# FIAT SERVICE LETTER

SUBJECT: FUEL SYSTEM  
VEHICLES: ALL 1976 MODELS

VALVE (PART #4362497) - LOCATED ON FUEL DELIVERY LINE BETWEEN FUEL TANK AND PUMP

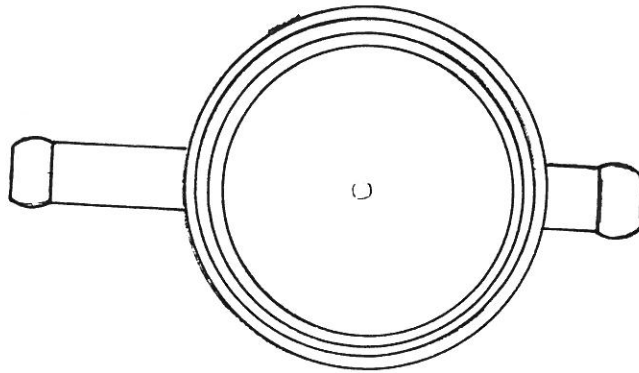
- the valve (part #4362497) is located on the fuel delivery line between the fuel tank and the fuel pump.
- the valve (part #4361910) is located near the carburetor on the fuel system line to the fuel tank.

Each valve is clearly marked with an arrow to indicate direction to the fuel flow.
